WARRANTY BULLETIN WARRANTY CAMPAIGN

Can-Am® On-Road Spyder™

Subject: **Spyder RT - LH Side Panel and Driver's
Seat Gap Correction**

No. **2022-3**

PROBLEM

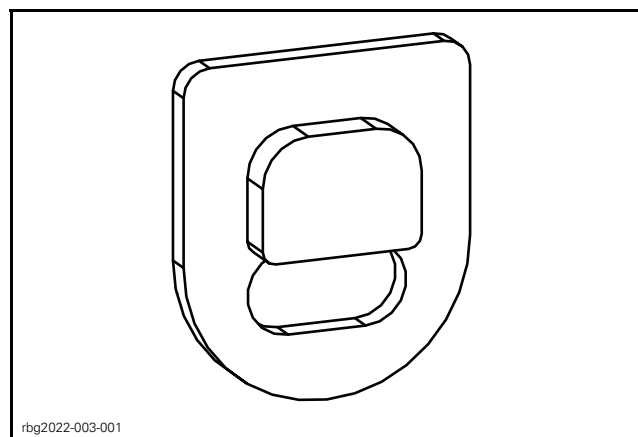
Some RT vehicles present a gap between the LH side panel and the driver's seat.

With the help of an adapter, enlarge the LH side panel fixation hole, pull up the panel and adjust the panel to reduce the gap.

AREA TO BE ENLARGED THROUGH THE ADAPTER OPENING

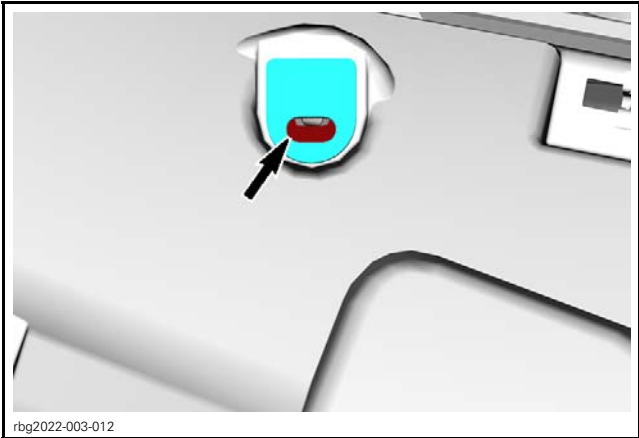
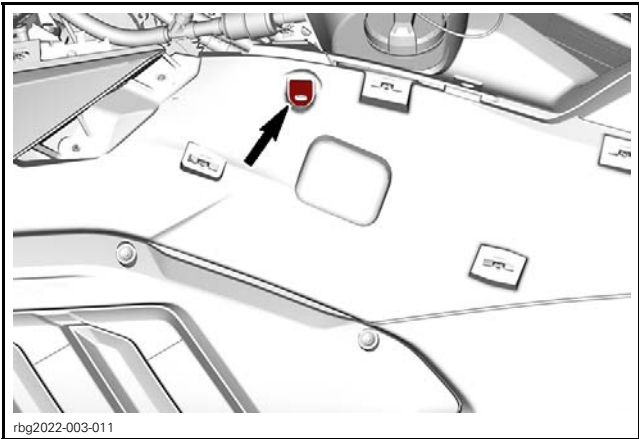
12. Install the adapter (P/N 705017687) on LH central fairing and use it as a template to enlarge the lower part of the hole. You may use a small rotary tool to enlarge the hole.

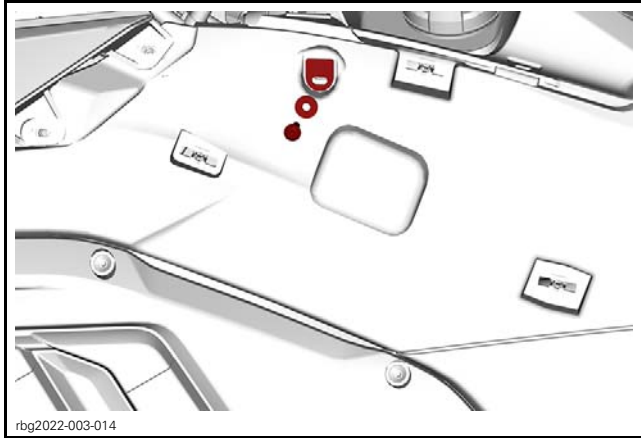
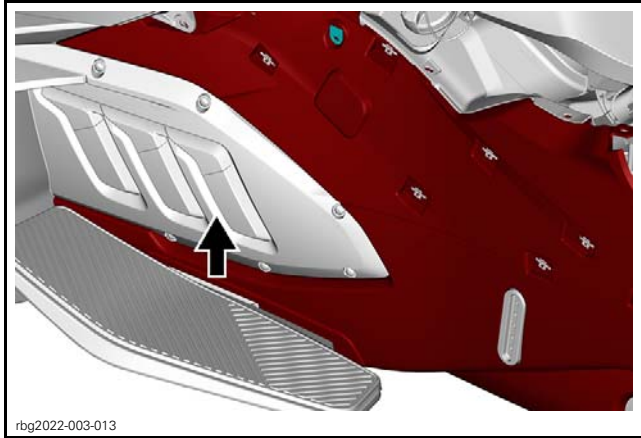
13. Apply a light upward pressure approximately to the bottom center of the LH central fairing (right about the middle of the driver's footboard) which allows the fairing to be raised and adjust then secure using the

adapter (P/N 705017687), the previously removed M6 X 25 screw and washer. Tighten to specification.

TIGHTENING TORQUE	
M6 X 25 Screw	3.5 N•m ± 0.5 N•m (31 lbf•in ± 4 lbf•in)
